Council Assessment Panel Minutes

18 October 2021

2.1 DEVELOPMENT APPLICATION 155/D017/2021 – NICHOLAS JAKE PEACOCK – 5 FOSTER STREET, NORWOOD

Figure 7

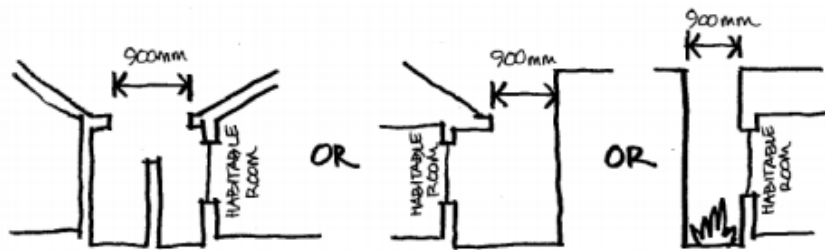
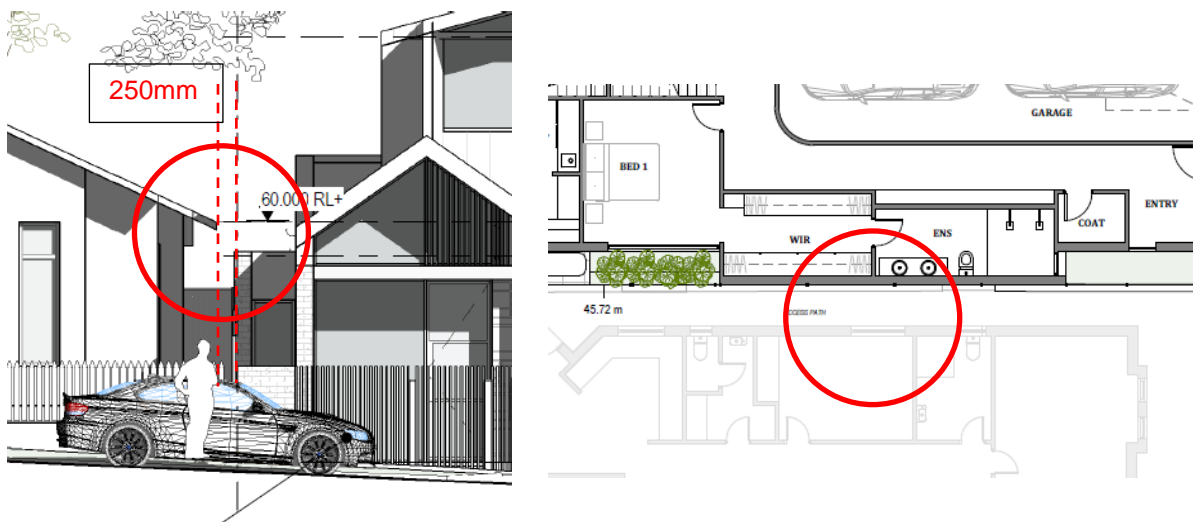
The proposed boundary wall of the southern dwelling does not allow for a 900mm horizontal distance which is clear to the sky, adjacent to an adjacent bedroom of the dwelling at 3/7 Foster Street, as shown in the images below.
